## Product Change Notification - SYST-21HDIC684

ERRATA - PIC32MX534/564/664/764 Family Silicon Errata and Data Sheet Clarification

**Description of Change:** 1) Added silicon issue 29. Module: &ldquo;USB Low-Speed Mode&rdquo;;  
2) Removed &ldquo;Features List&rdquo;; Data Sheet Clarifications.

## PIC32MX534/564/664/764 Family Silicon Errata and Data Sheet Clarification

FIGURE 1: EXTERNAL COMPARATOR SCHEMATIC EXAMPLE

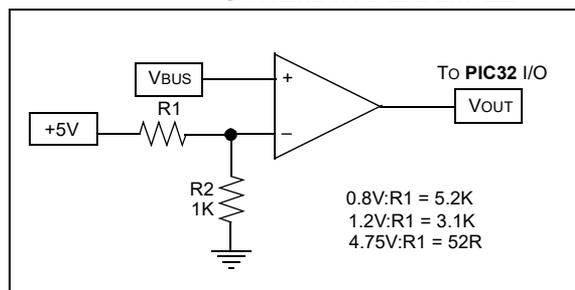
When the USB model is configured for OTG operation, it may not recognize all required OTG voltage levels on VBUS pin.

Use external comparator circuit to detect OTG specific voltage levels on VBUS pin.
